SERVICE BULLETIN

DATE: 26 SEPTEMBER 1994
PAGE 1 OF 6

FIREWALL FUEL FITTING MODIFICATION

Figure 1. Firewall Fuel Fitting Modification (Installation).

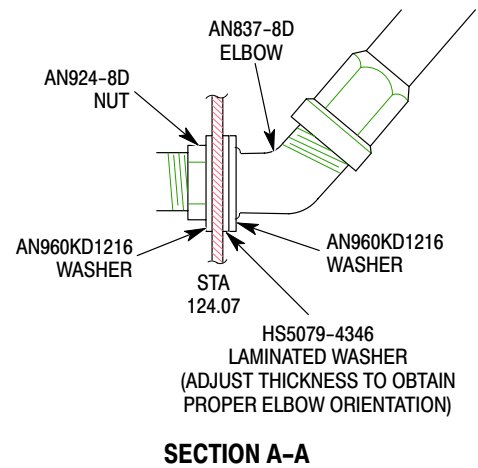
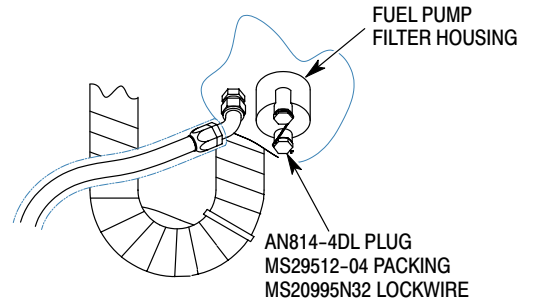
MDHI has received reports from the field of the station 124 firewall fuel fitting interfering with the landing gear brace. As a result, there is a possibility of the fuel fitting becoming damaged, thus creating a potential for fuel leakage. Therefore, MDHI is requiring all operators to modify their aircraft according to procedures contained in this Notice.

Operators are required to install an AN837-8D elbow at station 124.00 and remove the drain valve from the engine fuel pump filter housing.

- (3). Install AN924-8D (nut), (2) AN960KD1216 (washers), HS5079-4346 (laminated washer) and AN837-8D (elbow) as shown in Figure 1.
- (4). Ensure that AN837-8D is clocked 12° to 16° (25° to 29° for fuel systems equipped with anti-ice fuel filter installations) inboard as shown in Figure 1.

NOTE:
A/C EQUIPPED WITH ANTI-ICE FUEL FILTER INSTALLATIONS MUST CLOCK THE FITTING TO 25° - 29°.

NOTE: HS5079-4346 shim thickness may be adjusted to obtain proper elbow orientation.

- (5). Reassemble fuel cell lacing per the HMI Vol. I, Section 28-00-00.
- (6). Re-install hoses to the AN837-8D fitting (see Figure 1). Torque hoses per the HMI-CSP-2, Vol. I, Section 28-00-00.

- (7). Install AN814-4DL plug, MS29512-04 packing and MS20995N32 lockwire to engine fuel pump housing 369A8100-507 configurations only at location shown in Figure 1.
- (8). Re-fuel aircraft per servicing instructions contained in the Handbook of Maintenance Instructions (HMI).

Figure 2. Firewall Fuel Fitting Modification (Removal).

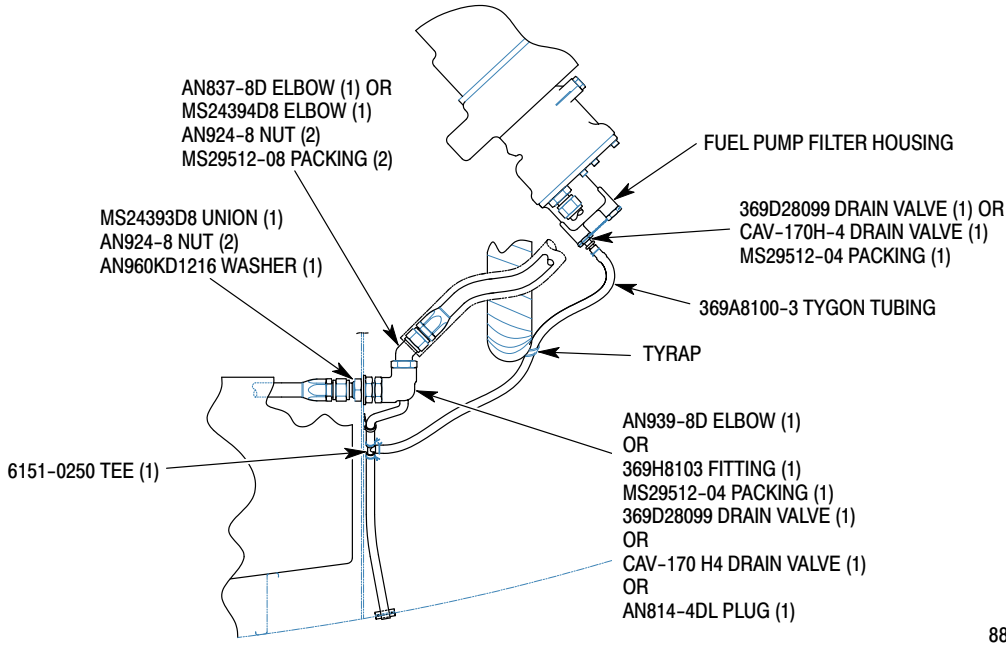
- (1). Refer to HMI Vol. I, Section 28-00-00 for access to fittings. This will require loosening the lacing supporting the fuel cell.
- (2). **If installed**, remove the following parts from the 369A8100-503, -505, -507, -509, -511, -703 and -705 fuel system installations: (see Figure 2)

MS24393D8	union, qty. 1
AN924-8	nut, qty.3
MS29512-08	packing, qty.2
369H8103	fitting, qty. 1
369D28099	drain valve, qty. 1 or 2
CAV-170-H4	drain valve, qty. 1 or 2
369A8010-85	tygon tubing
MS29512-04	packing, qty. 1 or 2
TY-25M	ty-rap
369A8100-3	tygon tubing
369A8100-5	tygon tubing
369A8100-7	tygon tubing
AN837-8D	elbow, qty. 1
MS24394D8	elbow, qty. 1
AN814-4DL	plug, qty. 1
AN939-8D	elbow, qty. 1
6151-0250	tee, qty. 1
